1992 - 1993 Corvette: Recall: Power Steering Gear Inlet Hose

Subject: PRODUCT SAFETY CAMPAIGN 93CO2 - POWER STEERING GEAR INLET HOSE

Model and Year: 1992-93 CHEVROLET LT1 CORVETTE

Bulletin Number: 93C02

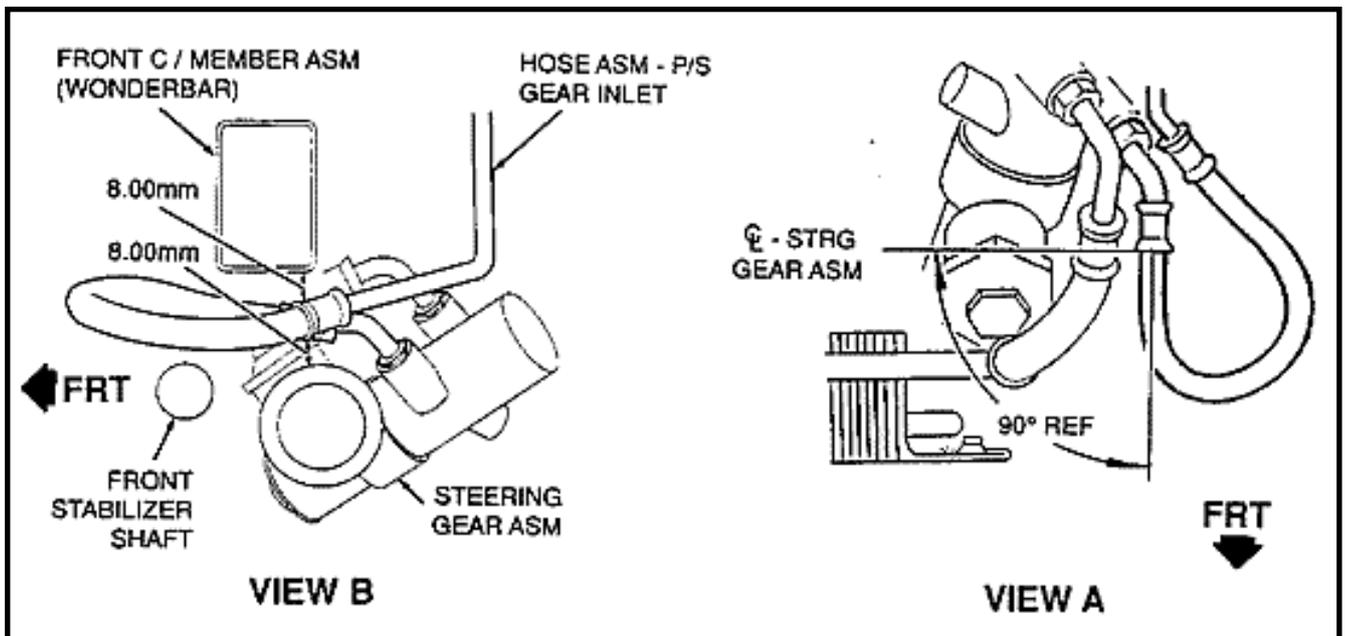
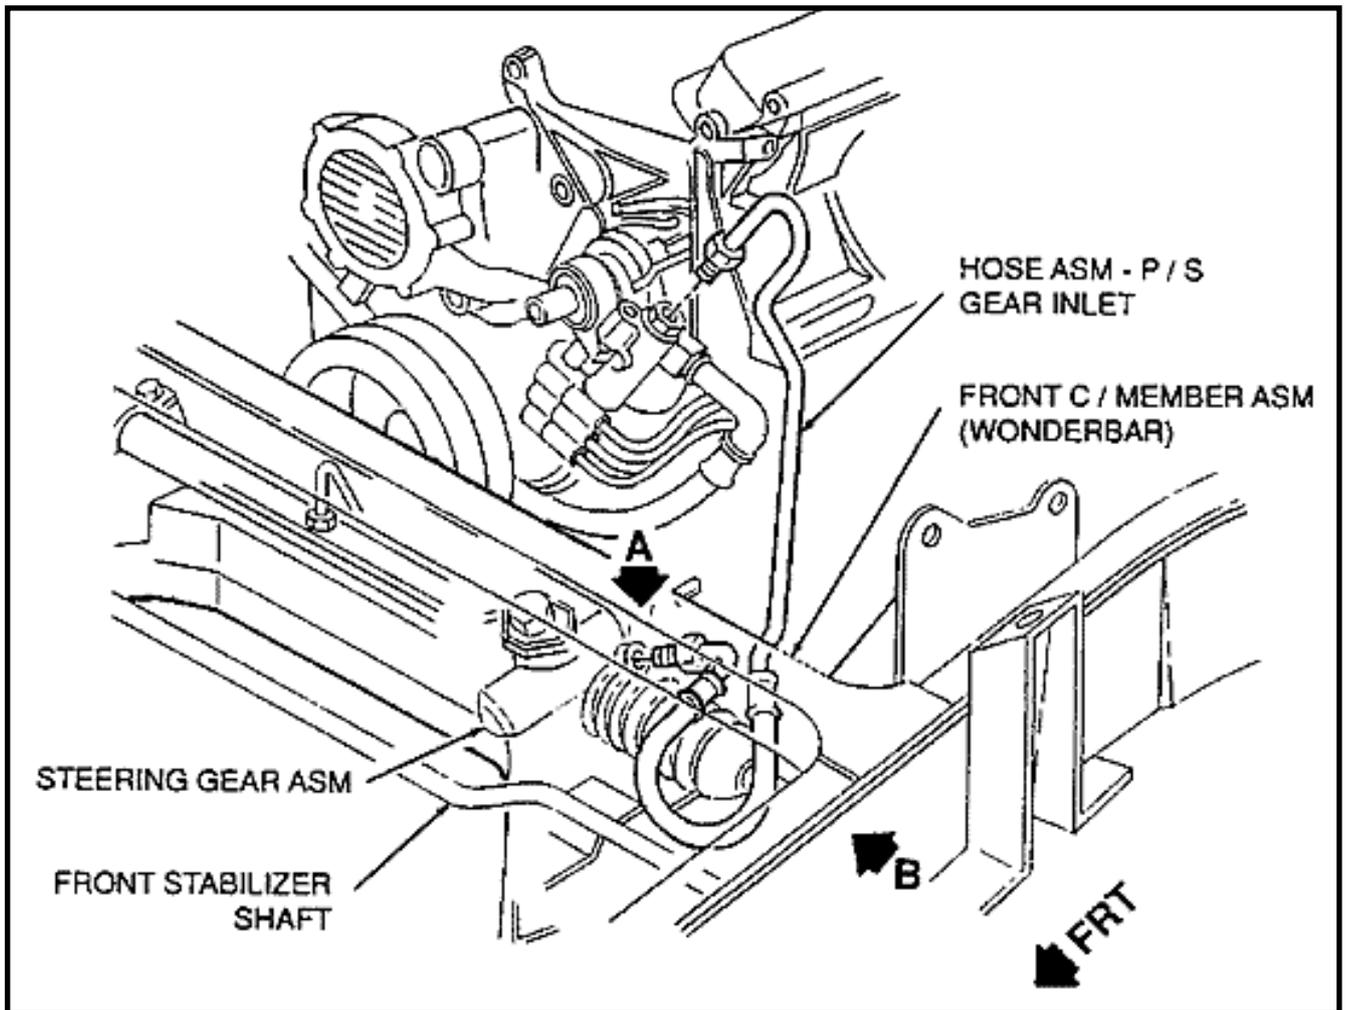
General Motors has determined that a defect which relates to motor vehicle safety exists in certain late 1992 and early 1993 Chevrolet Corvette model vehicles equipped with LT1 engines. These vehicles were assembled with a power steering gear inlet hose which may fracture. Since the fluid within this hose is under pressure, fracture of the hose could cause power steering fluid to spray out of the hose and, if an ignition source is present, an

To prevent this condition from occurring dealers are to replace the power steering gear inlet hose on involved vehicles.

Figures on page 4 may assist in performing this repair procedure.

Notice: Be certain to leave adequate clearance between front cross-member and hose/pipe assembly. View B on page 4 illustrates proper clearance.

1. Install new power steering gear inlet hose following procedures on page 3B-6 of either

the 1992 Corvette Service Manual (ST-364-92-1) or the 1993 Corvette Service Manual (ST-364-93PSID).
